SOLERA SALON CENTENNIAL
8770 EAST ARAPAHOE ROAD

GRADING PLAN

REVISIONS:
CITY REVIEW 17 DEC 2007
CITY REVISIONS 21 DEC 2007
CITY REVISIONS 02 JAN 2008

C2.0
SHEET 3 OF 6

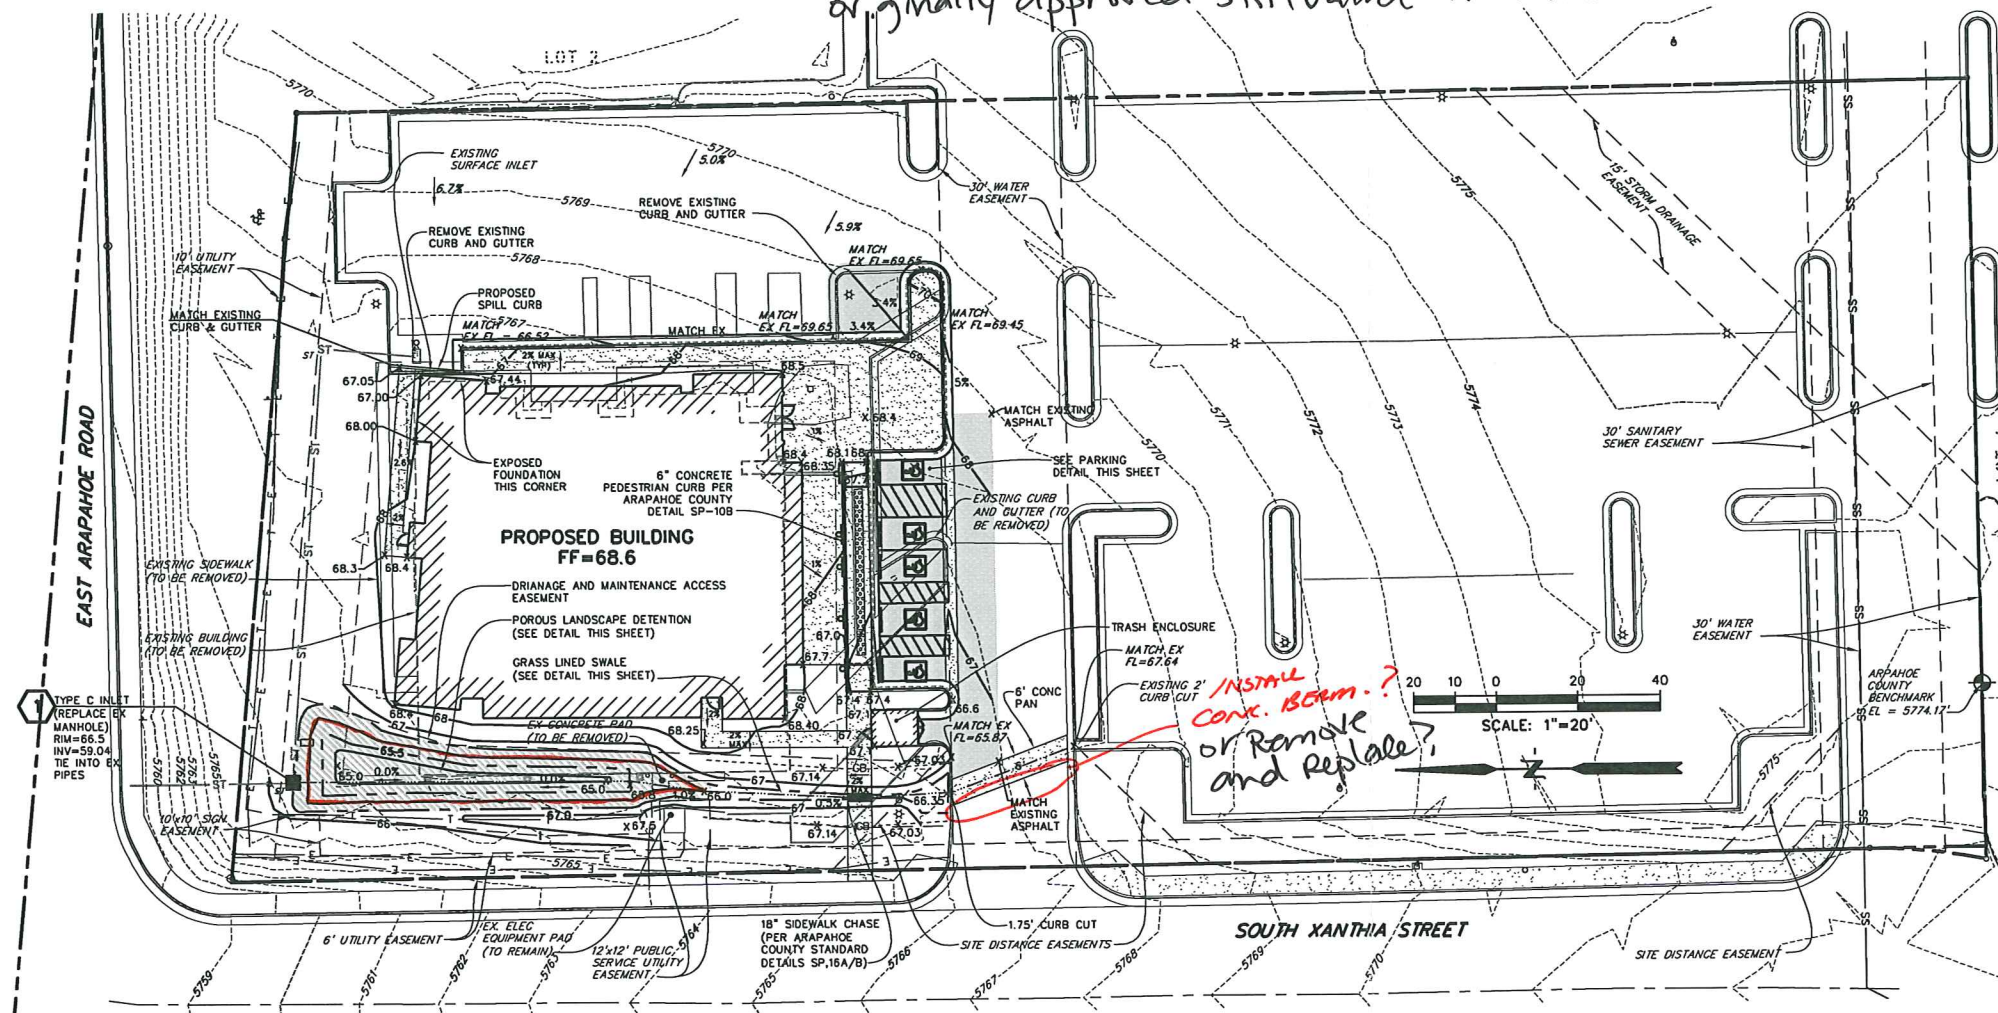
- Submit final drawing as a formal
CD Amendment (cover sheet, cert. statement,
signed, stamped, etc.) and note all notes
originally approved still valid for this amendment.

PARKING DETAIL
1" = 10'

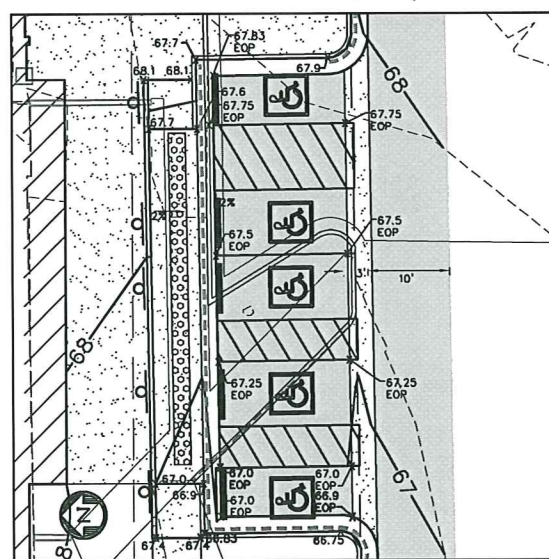
- Show utilities
- Buldd proposed changes

GRASS SWALE SEDIMENTATION FACILITY SECTION
N.T.S.

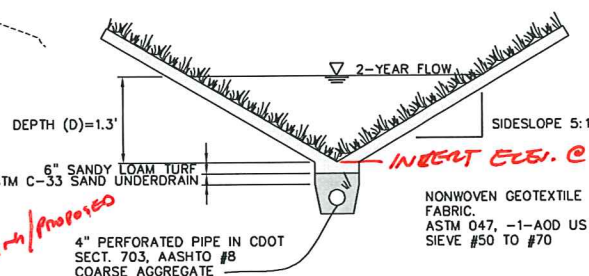
Nm -
woven
include
specs.

all out
allowable min/max
longitudinal slope on
underdrain.
